ADDENDUM NO. 1

DATE: February 23, 2026
TO: ALL PLAN HOLDERS
FROM: Mead & Hunt, Inc.
SUBJECT: La Crosse Regional Airport
Airport Rescue and Firefighting (ARFF) Building Rehabilitation
LSE1023

TRUE PLAN
NORTH NORTH
1 **FIRST FLOOR SECURITY PLAN**
1/4" = 1'-0"

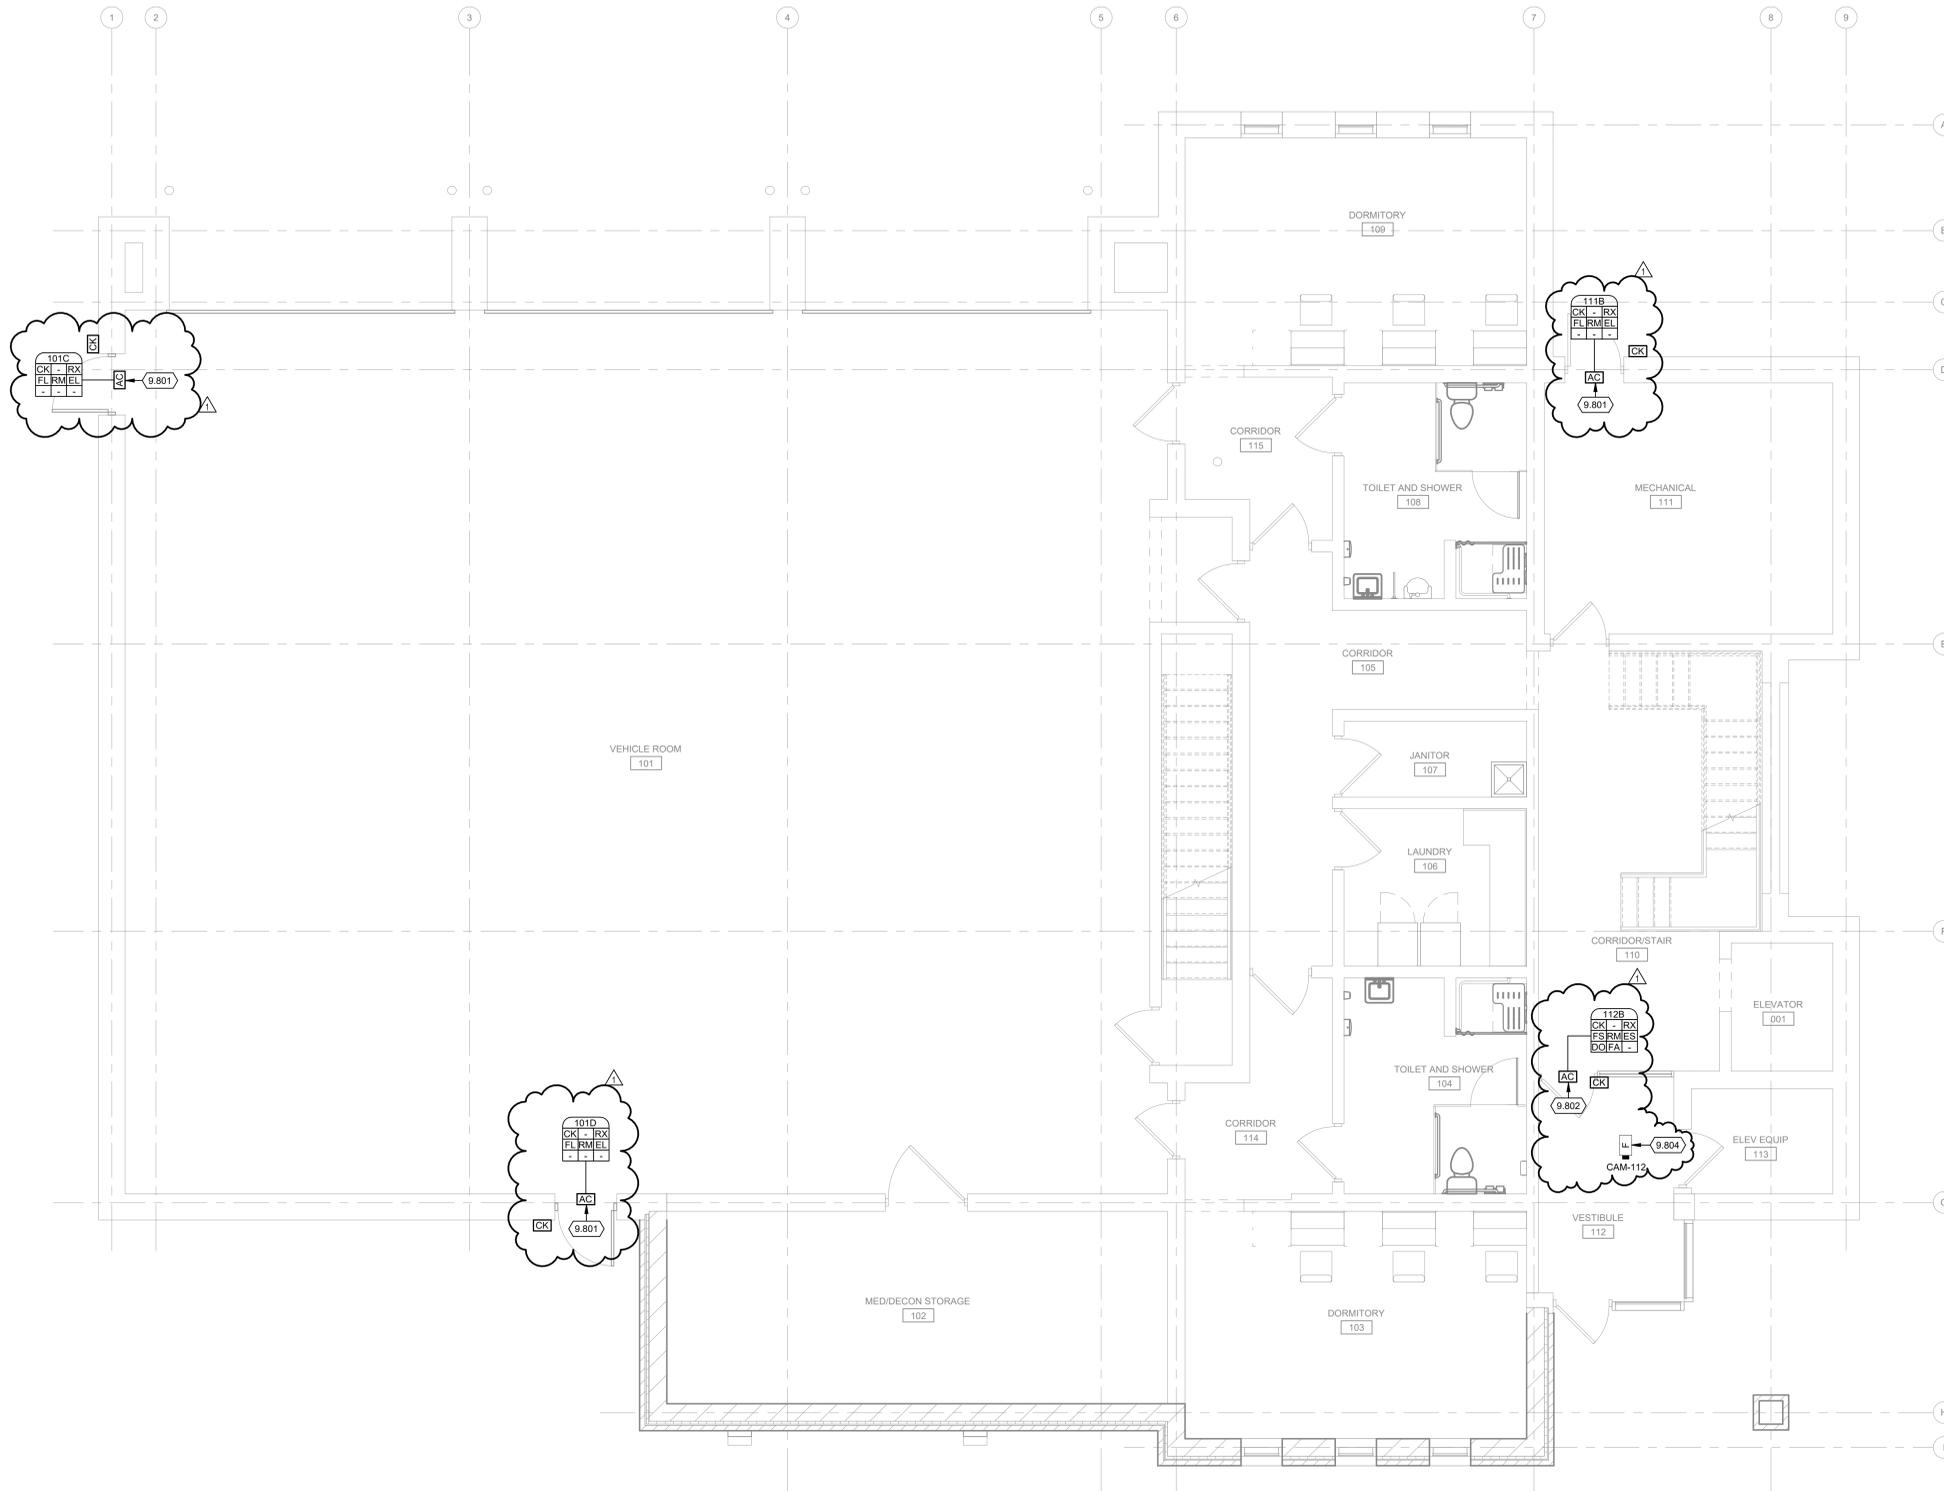
9. Add the following note to Plan Sheet 101: "There are four existing bollards in the concrete removal and replacement area. If bollards are disturbed during construction, they are to be removed and replaced as part of this project work scope."
10. Sheet T-121: Revise access-controlled doors to remove second credential readers and revise tags to match. Add keyed note to clarify camera cabling.
11. Sheet T-122: Add keyed notes to clarify camera cabling and rough-ins.

5 ACD - SINGLE DOOR - POE LOCKSET
NO SCALE

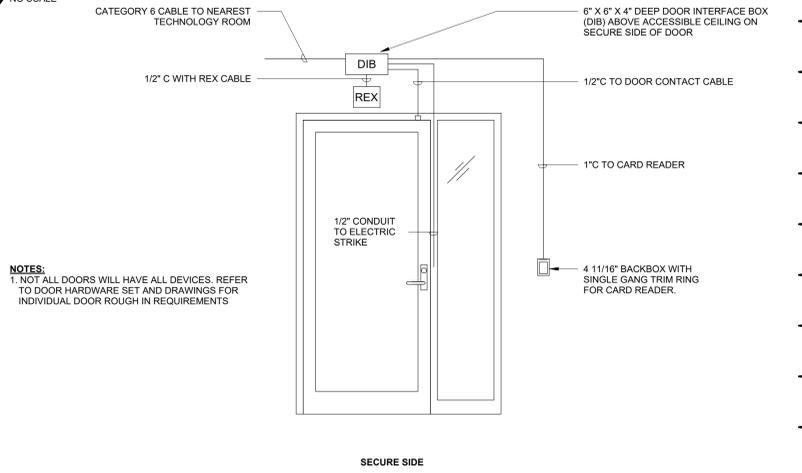
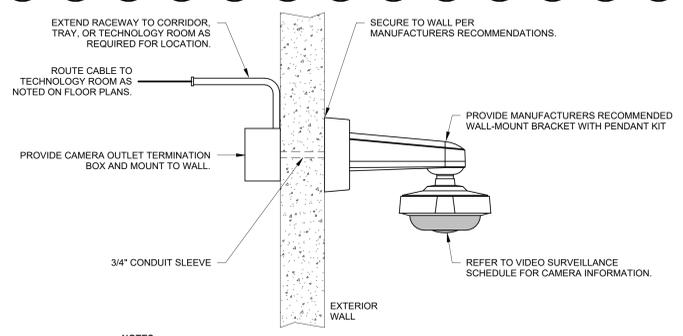
12. Sheet T-501: Revise access-controlled door details to match door requirements.
13. Sheet T-601: Revise Access-Controlled Door and Video Surveillance schedules to match modifications on drawings.

19. **QUESTION:** Door 101C lists a reader on each side of the door and a REX, (you don't use a REX with double readers). Door 111B same as above. Door 101D same as above, and what is "BR"? **ANSWER:** All doors will be read-in only with a credential reader on the exterior. Doors 101C, 101D, and 111B are specified in Division 08 to receive a PoE lockset which has the reader integrated with the lockset. The "BR" tag will be removed.
